**Statewide Utility Codes and Standards Team Comments on Lighting Topics in 2019
Title 24, Part 6 Express Terms**

Comments on Lighting Topics in 2019 Title 24, Part 6 Express Terms

California Statewide Utility Codes and Standards Team

November 3, 2017

Figure 1: 2014 average online pricing for dimmable vs. non-dimmable LED lamps, based on hundreds of price points collected from nine online retailers.

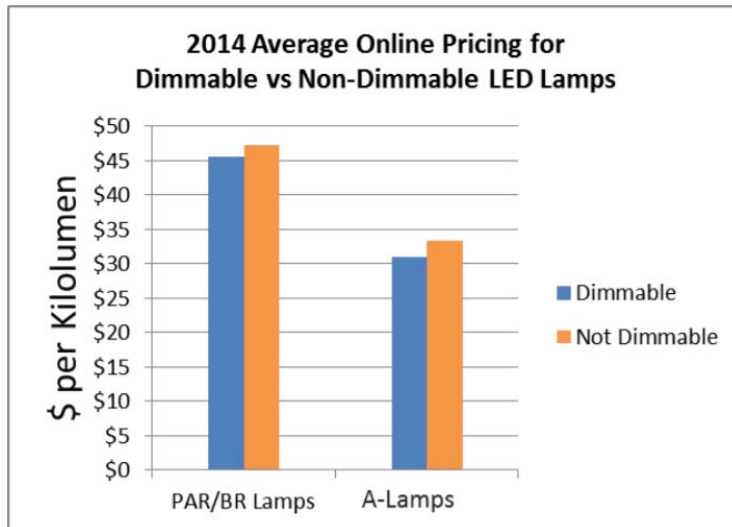
Further, 2016 JA8 requires dimmability, a requirement which was demonstrated to be cost-effective when the 2016 Standards were adopted. Dimmability does not result in a cost adder for LED lamps, and most LED lamps are dimmable. This is consistent with comments the Statewide CASE Team has heard from industry contacts who are either in the driver manufacturer community or who have conducted research into dimming driver incremental costs. These stakeholders suggested that the incremental cost for an LED driver to be dimmable is small and shrinking. Estimates in 2014 ranged from \$0.15 to \$0.20 incremental manufacturer cost, but were expected to drop to \$0.05 or less within three years. To verify that the incremental manufacturer cost to add dimmability is indeed small, the Statewide CASE Team has conducted an analysis of thousands of retail prices collected from 9 online retailers. As shown in

Figure 1, online prices for dimmable LED replacement lamp products (based on price points from hundreds of products collected throughout 2014, and prices have dropped since then) are actually slightly lower on average than prices for non-dimmable products. This suggests that any incremental manufacturer cost associated with making a product dimmable is negligible. It also stands in stark contrast to the linear fluorescent / compact fluorescent lighting market, where historically few products were dimmable and they carried significant incremental retail prices.
